TVA Response to Request for Additional Information

SEQUOYAH NUCLEAR PLANT (SQN) UNITS 1 AND 2 RESPONSE TO REQUEST FOR ADDITIONAL INFORMATION (RAI)

The following provides TVA's response to NRC's RAI letter dated August 11, 2006.

Figure 1 – Sequoyah containment plan view, elevation 679.78'

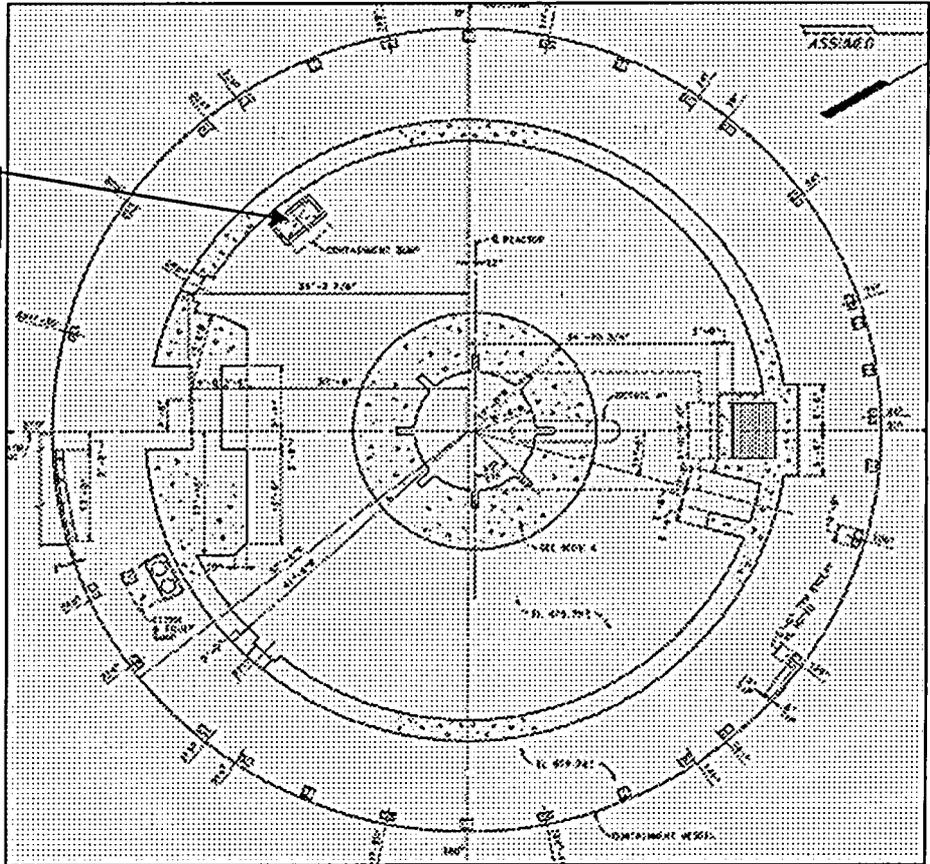
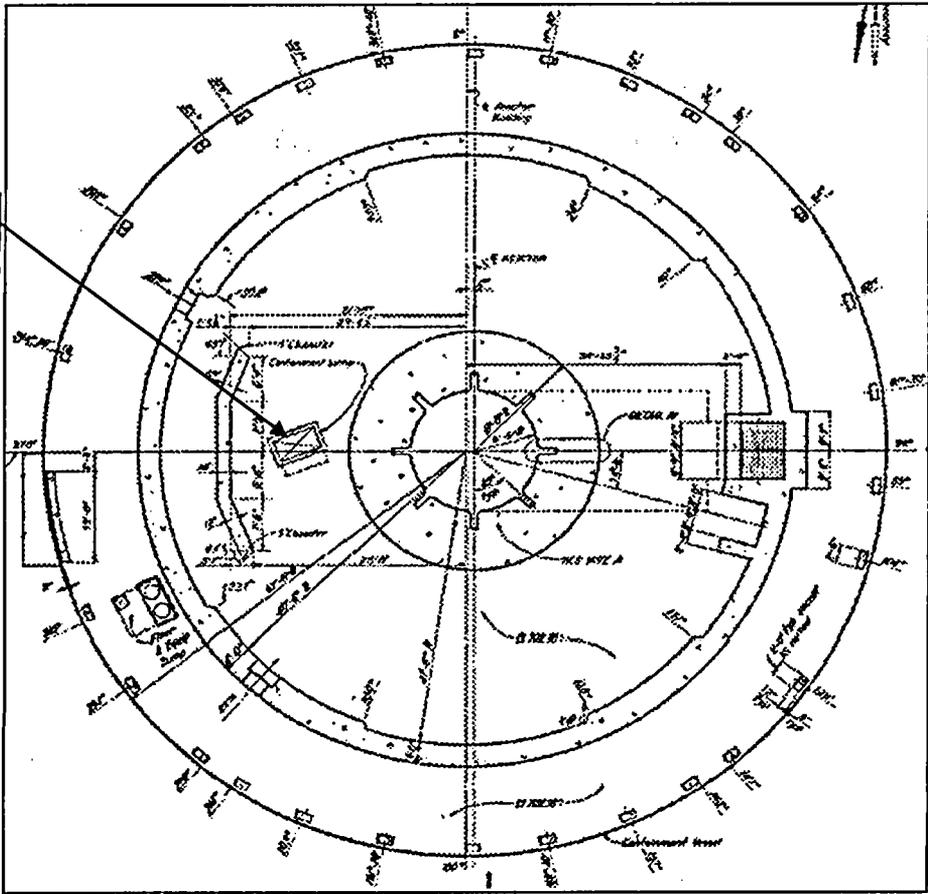
- (b) Watts Bar and Sequoyah are similar plants. The staff is currently performing an audit of the Watts Bar sump modifications and has gained a broad understanding of the proposed changes. To what extent do the two units have the same transport analysis? Please provide the inputs,

boundary conditions, geometry, that were different from Watts Bar's transport analysis (if any).

The sump cavity volume for SQN and WBN was 461 cubic feet (ft³) and 680 ft³, respectively. The total water volume for the sump recirculation pool depth of 6 inches for SQN and WBN was 1,693 ft³ and 1,747 ft³, respectively. The geometrical differences outlined above caused the pool fill transport fractions for SQN and WBN to be 27% and 39%, respectively.

Figures 1 and 2 show the containment plan views for SQN and WBN. Aside from the difference in elevation at which each view is taken, there are slight differences in the overall layout of each containment. These differences are displayed in the figures below:
